Official Transcript of Proceedings
NUCLEAR REGULATORY COMMISSION

Title: Advisory Committee on Reactor Safeguards
Materials, Metallurgy and Reactor Fuels

Date: Tuesday, May 10, 2011

SUBCOMMITTEE ON MATERIALS, METALLURGY AND REACTOR

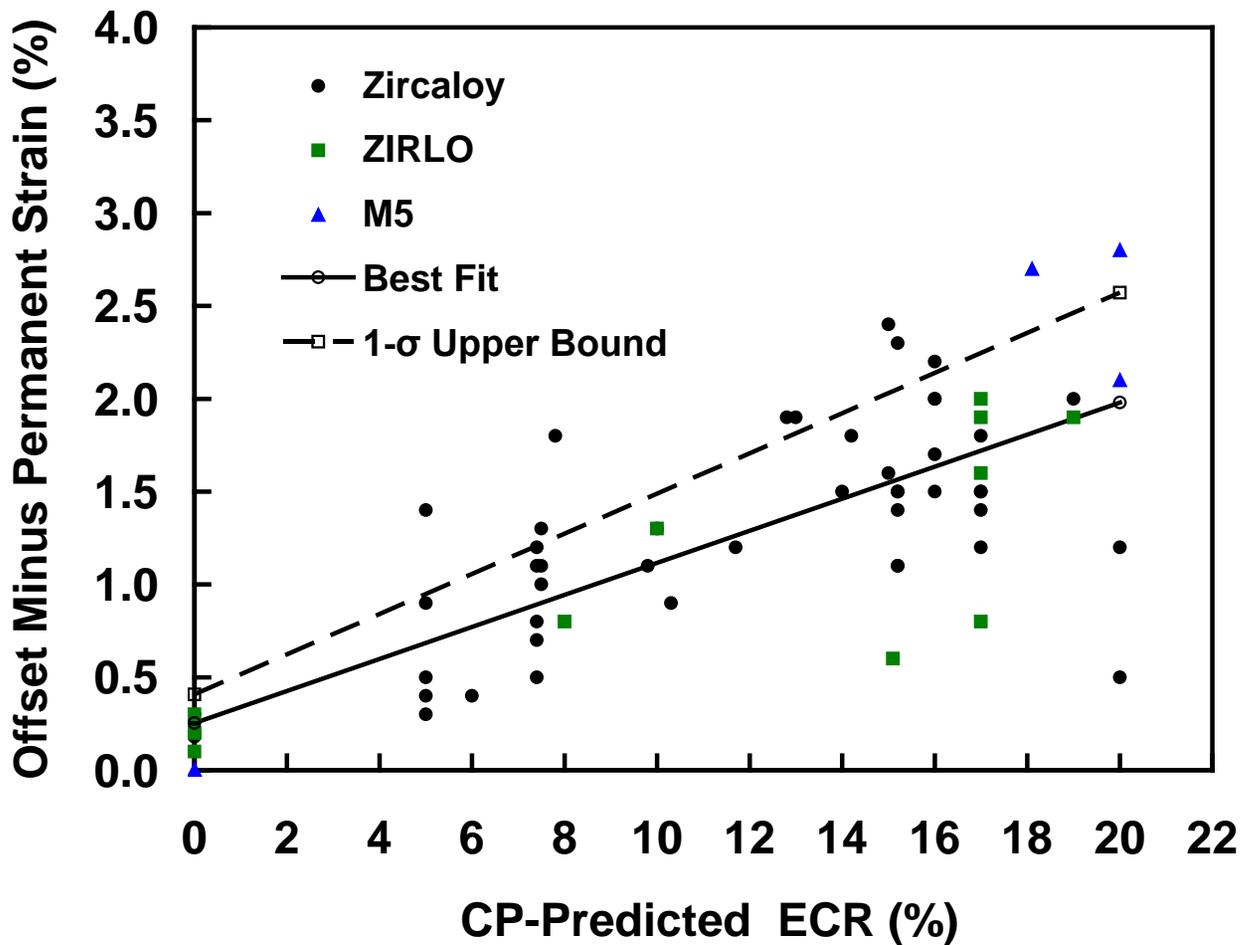
12 MS. FLANAGAN: So, the discussion that
13 Mike is referring to here is in the test procedure for
14 post-quench ductility testing in Appendix C. And the
15 plot -- and the upper bound that Mike is referring to
16 is shown here in figure C-1. So here, it's the
17 relationship between permanent strain and offset
18 strain, and then really the scatter and the results.
